CERTIFICATE OF APPROPRIATENESS

**RE: Application Number 20-6985; 427 Henry; Cass-Henry Historic District
Project Scope: Rehabilitate Apartment Building**

RE: 427 Henry—The Henry

HENRY STREET REDEVELOPMENT

Sheet
5A401

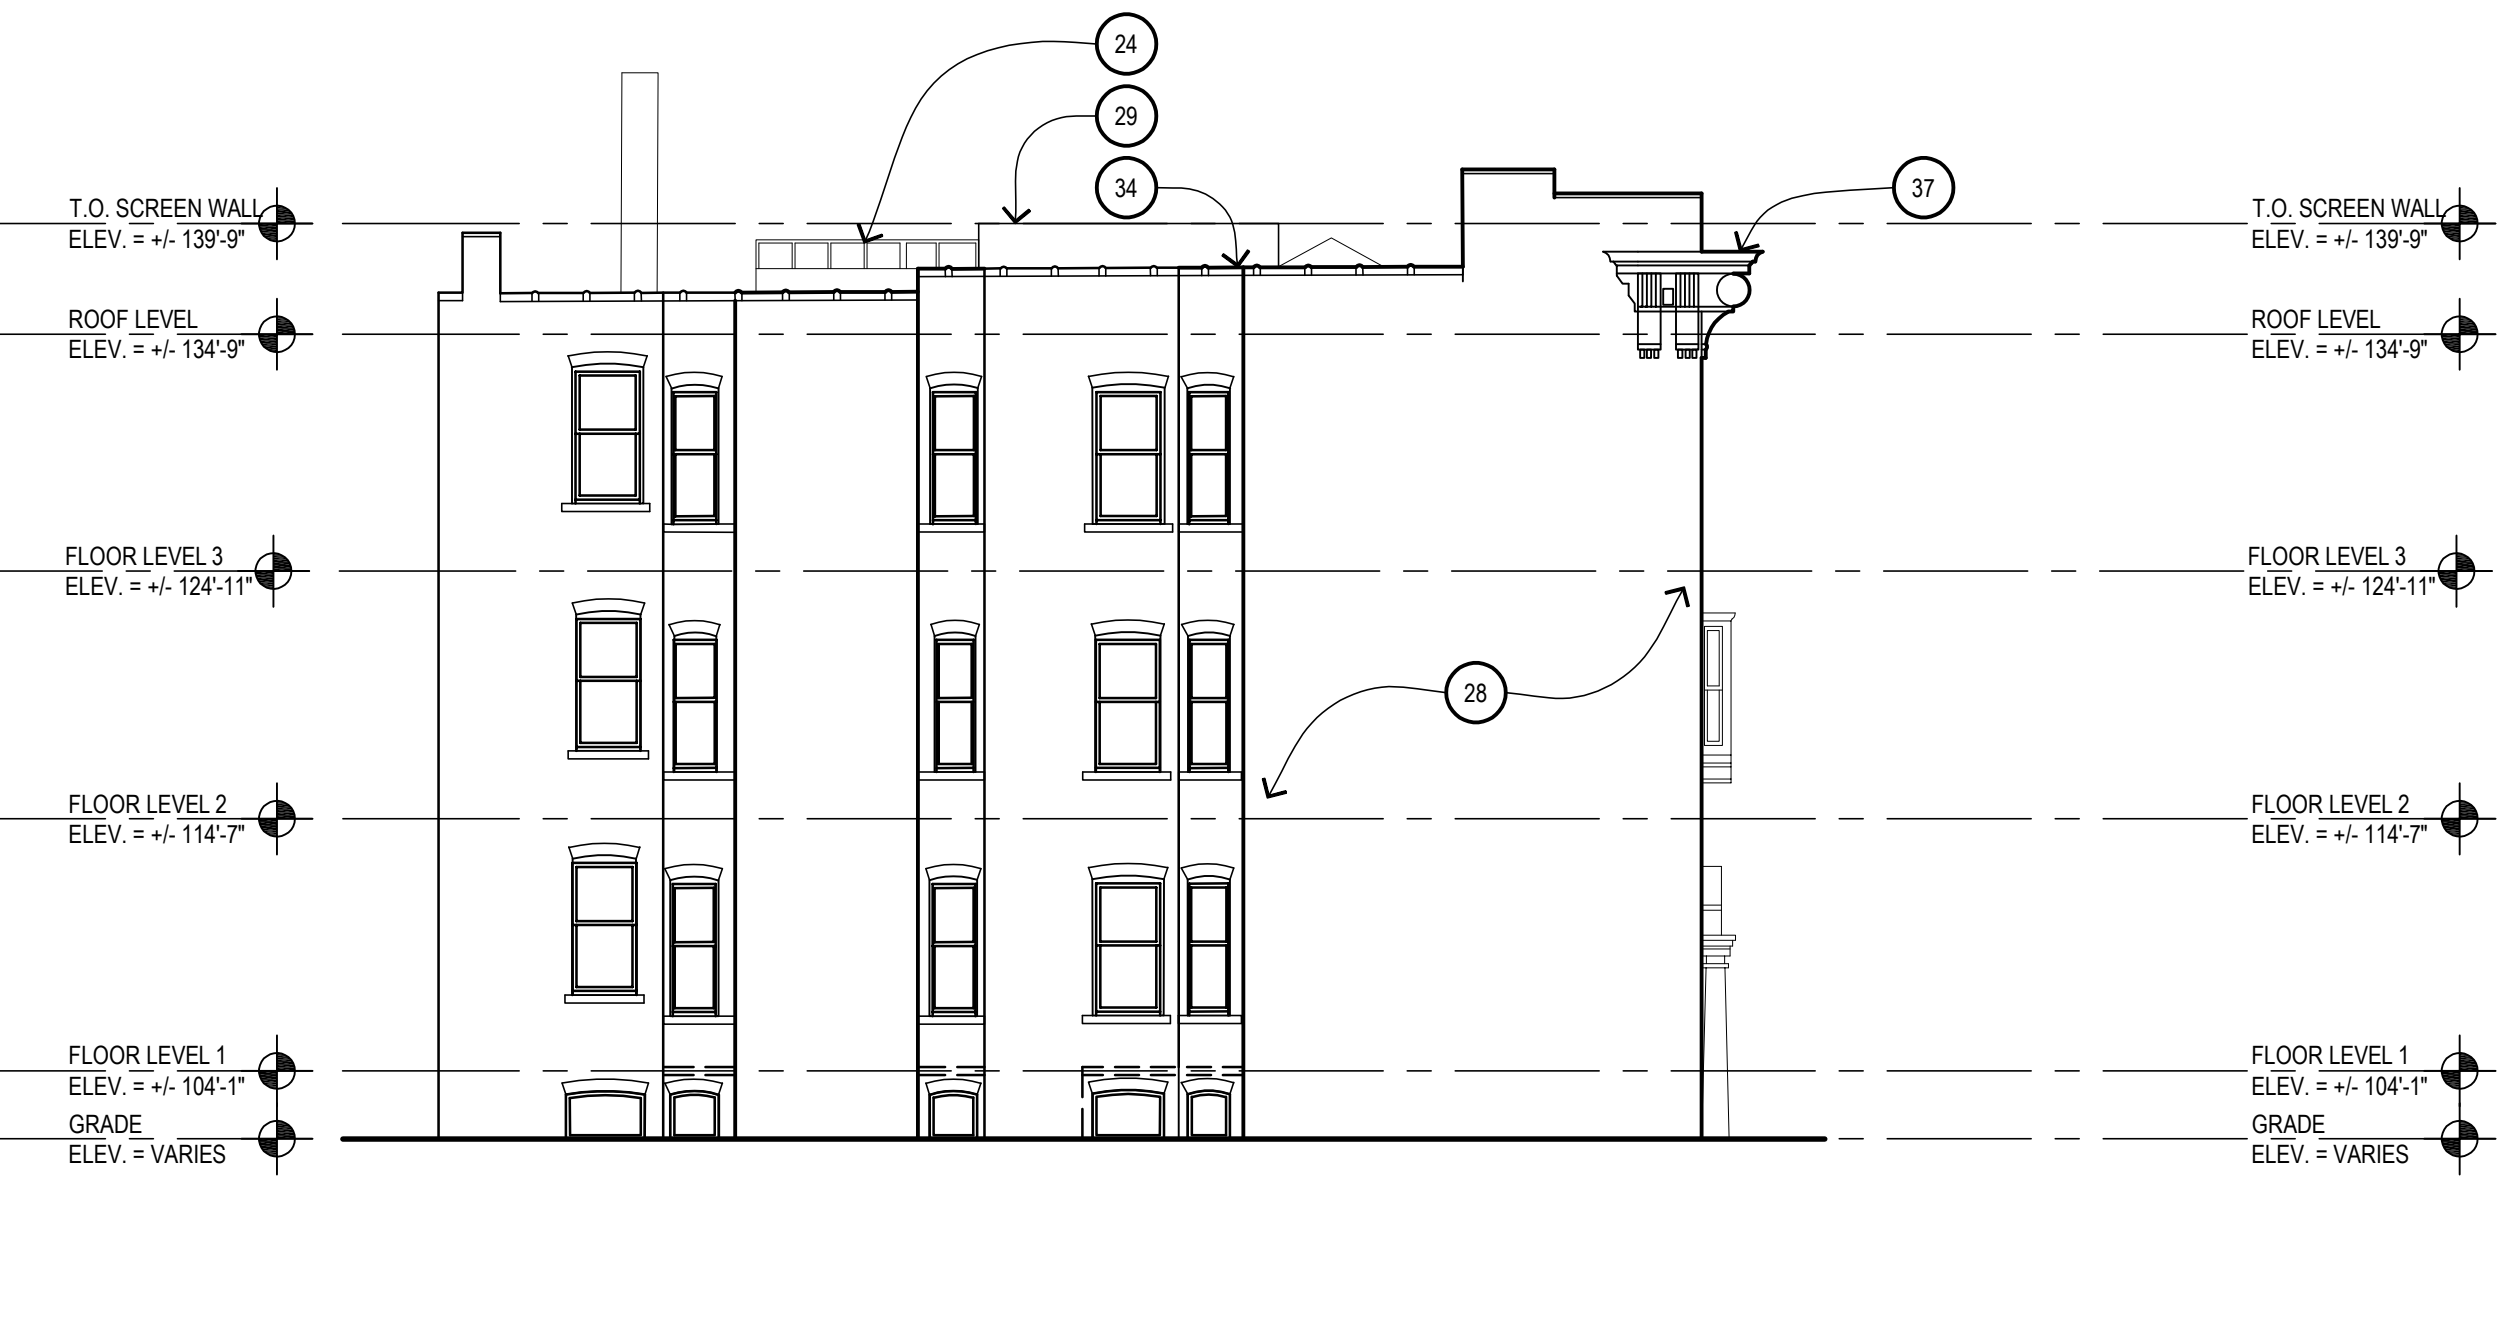
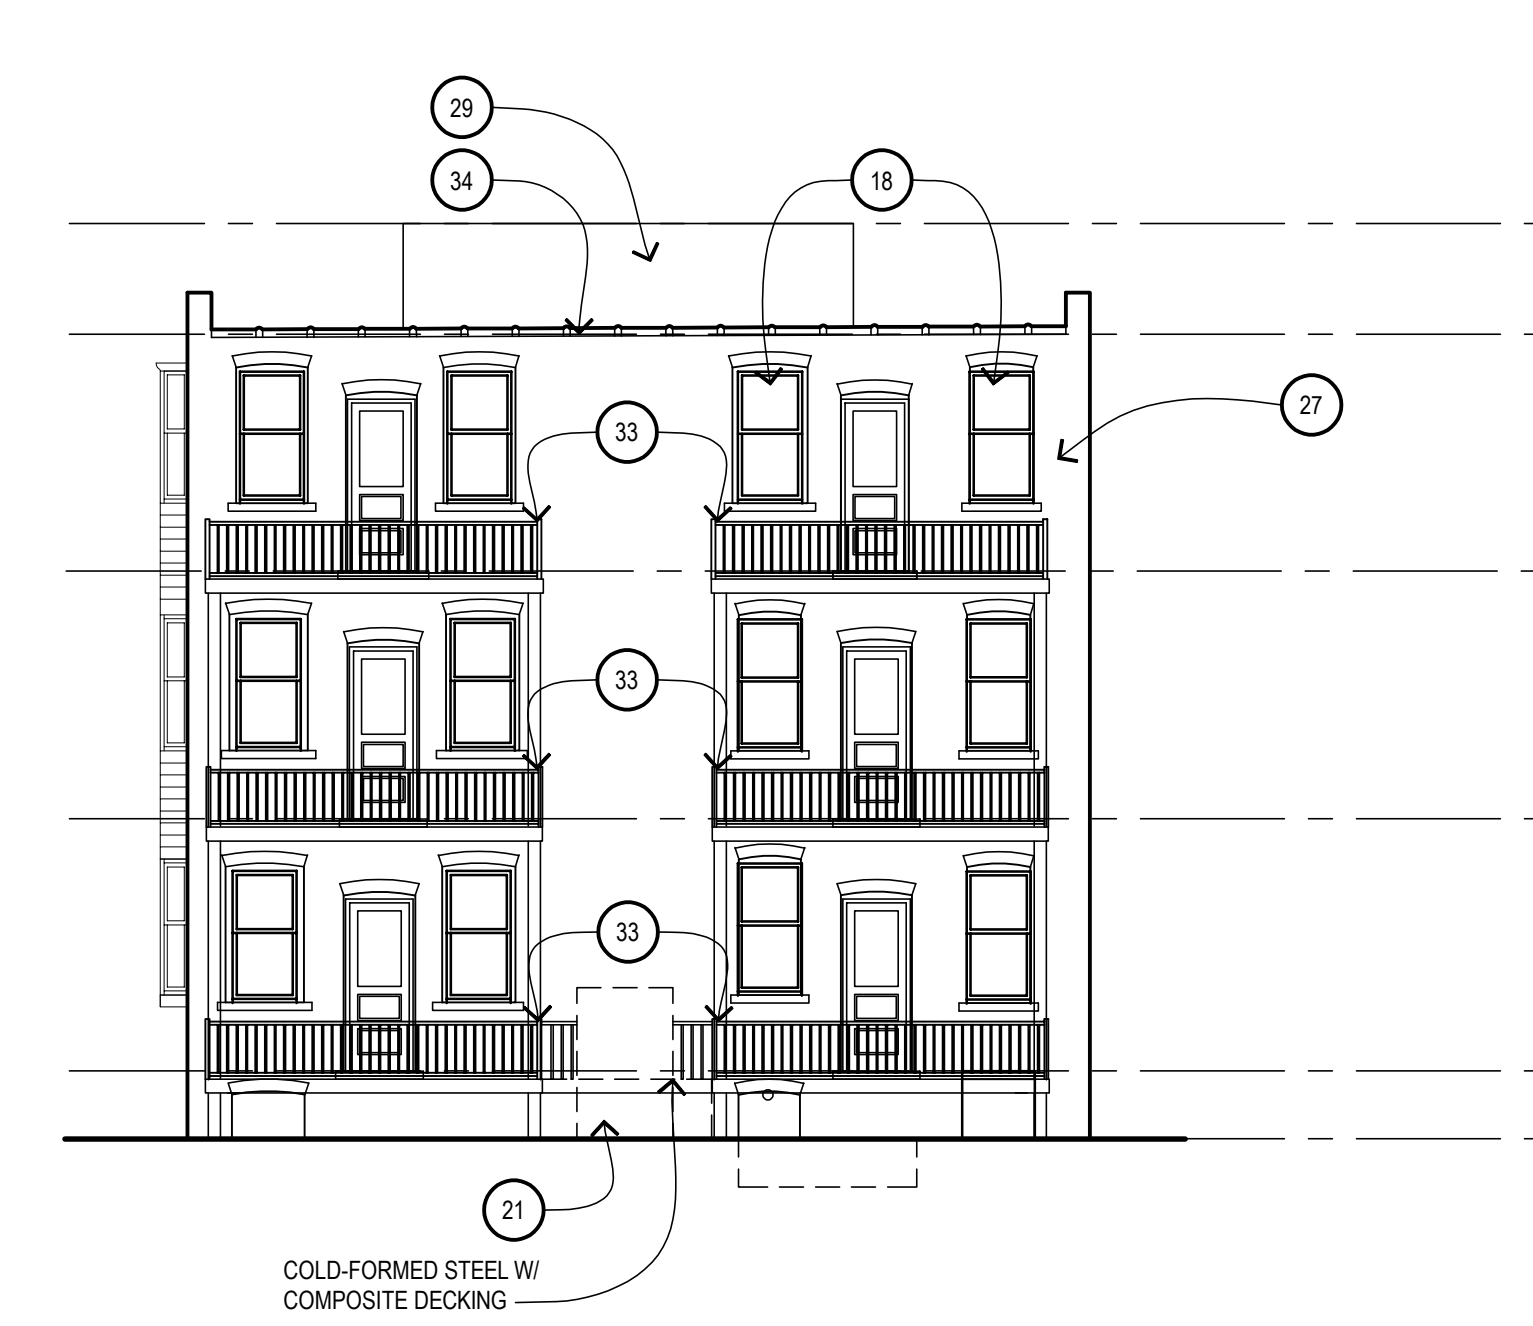
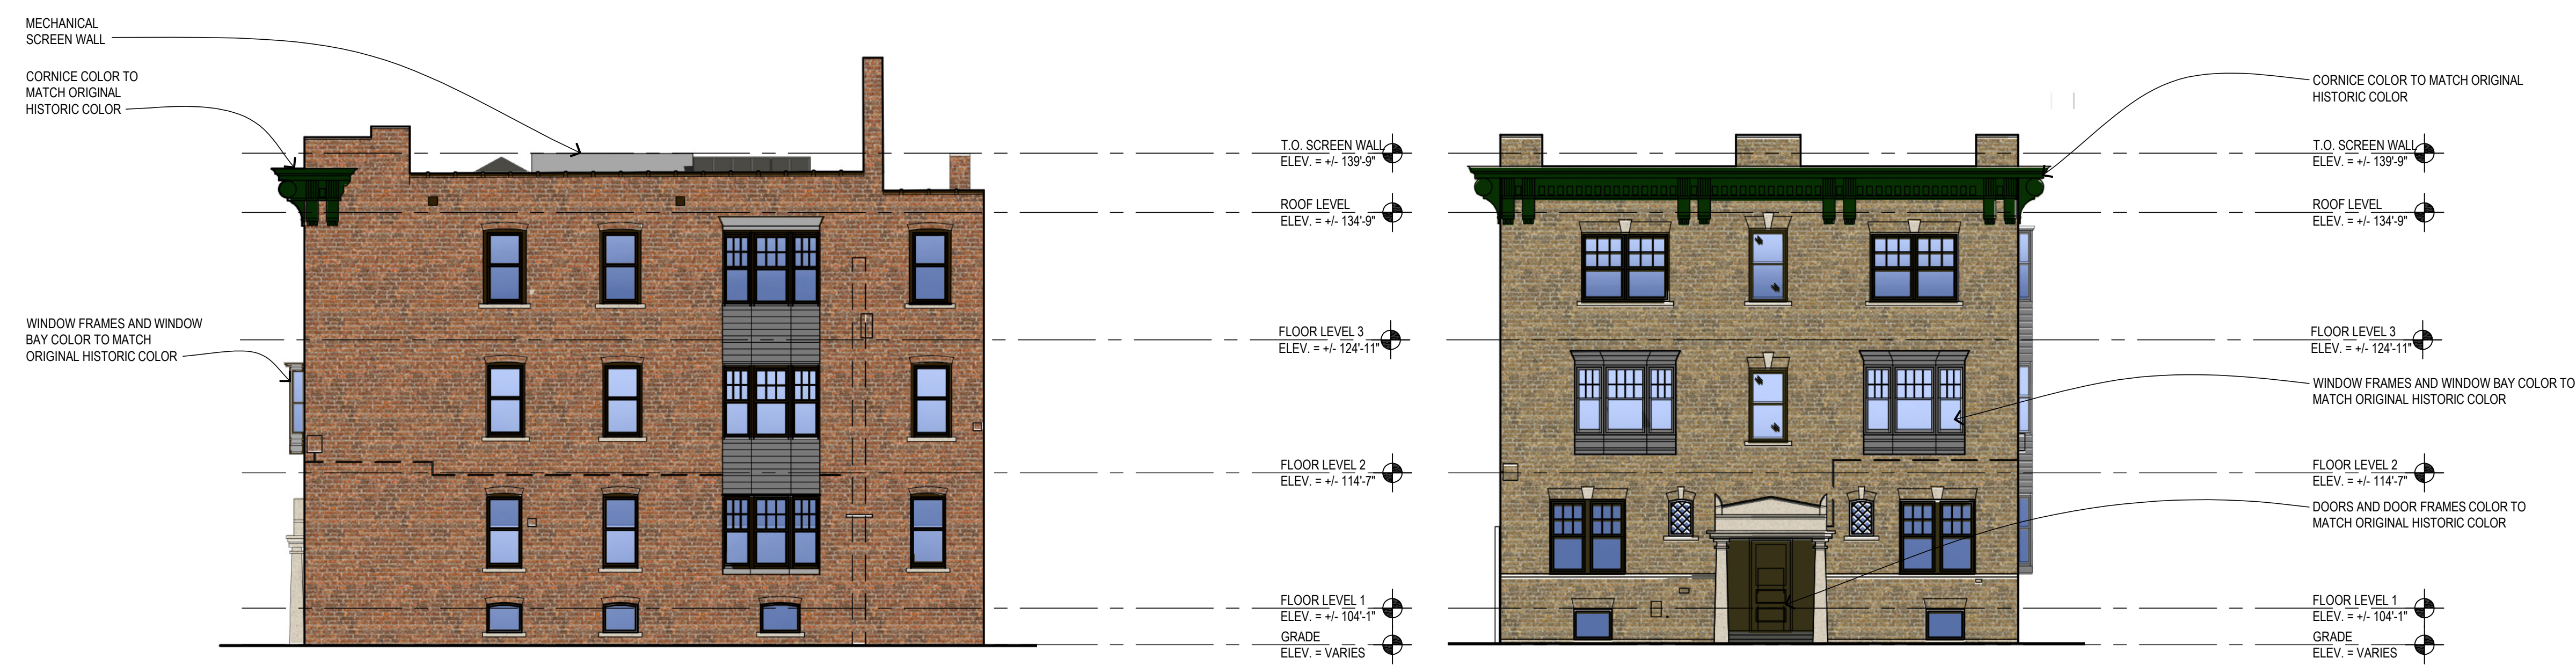
- *A new cornice made of GFRP or fiberglass, supported by paired brackets and based upon the existing cornices on 439 and 489 Henry, as referenced in (revised) drawing 5A401 received 11-25-20*

And, as per the submitted documents, specifically drawings 5A101 (floor/roof plans), 5A401, 5A401.1 (elevations), and 5A421 (window details).

Sheet
5A421

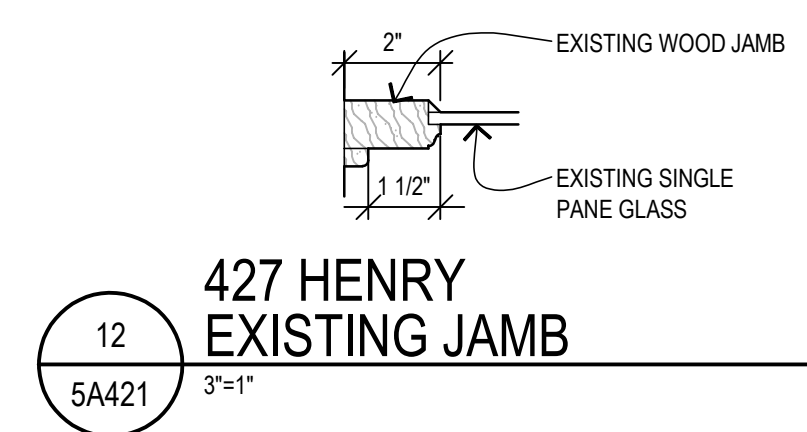
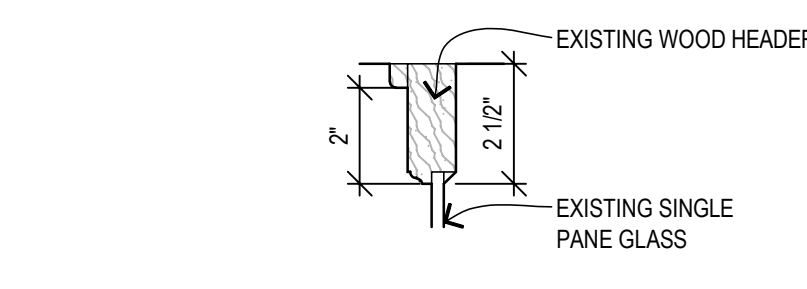
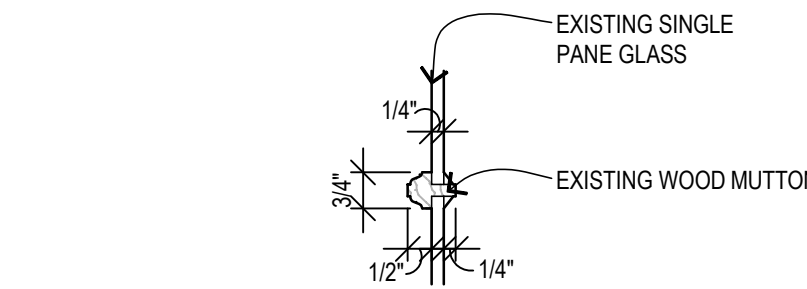
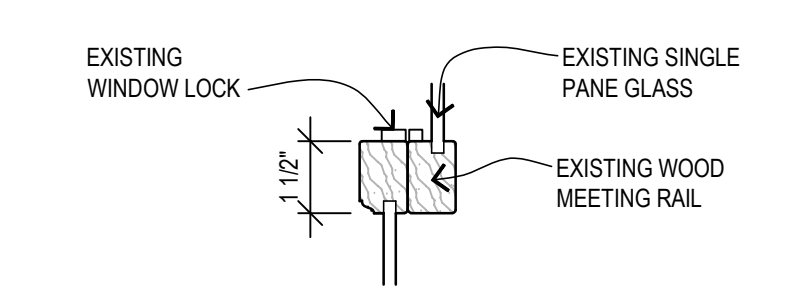
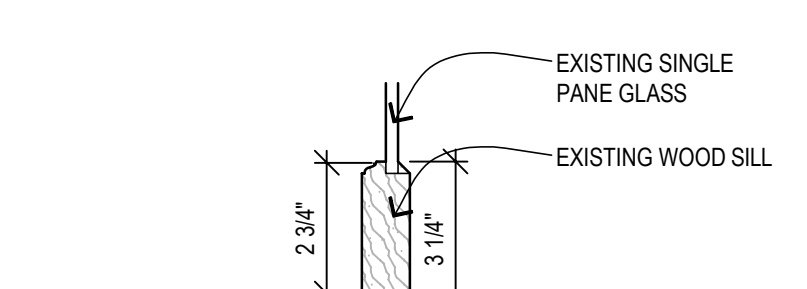
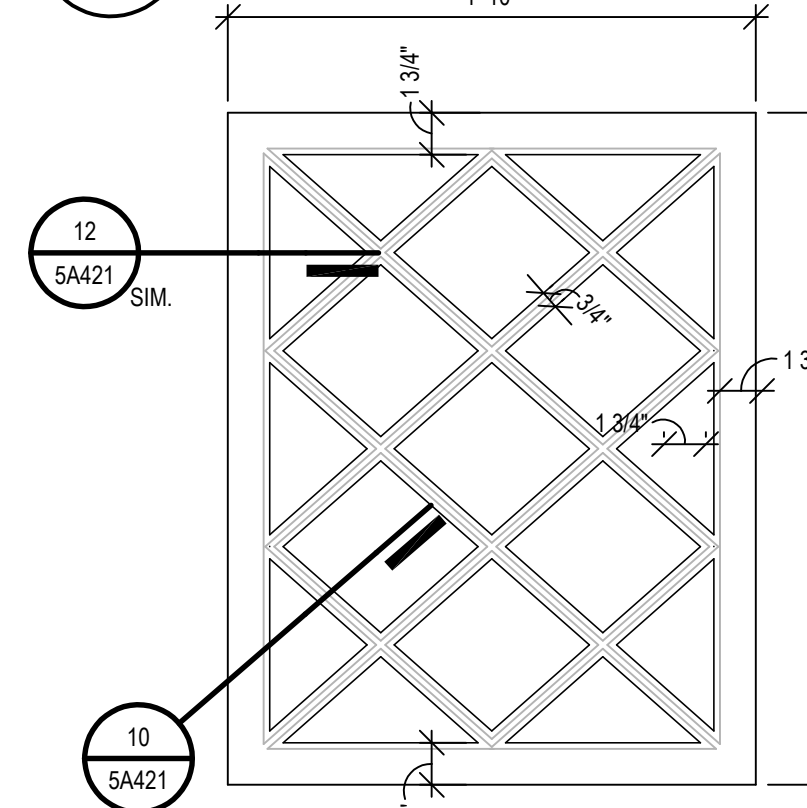
- *New historic replica aluminum-clad wood windows throughout: Marvin Ultimate Double Hung G2 per attached data sheet (color TBD)*
- *On the north (primary) façade, two 1/1 windows will replace the existing (non-historic) 1/1 windows in the center bay. At the two end bays, 6/1 windows will be installed at the first and third floors. The bay windows will receive new 8/1 and 6/1 windows, some of them replacing historic-age windows.*

- *The existing fixed historic-age wood windows flanking the entrance (with diagonal wood muntins) will be replaced with units that match existing profiles and sight lines.*
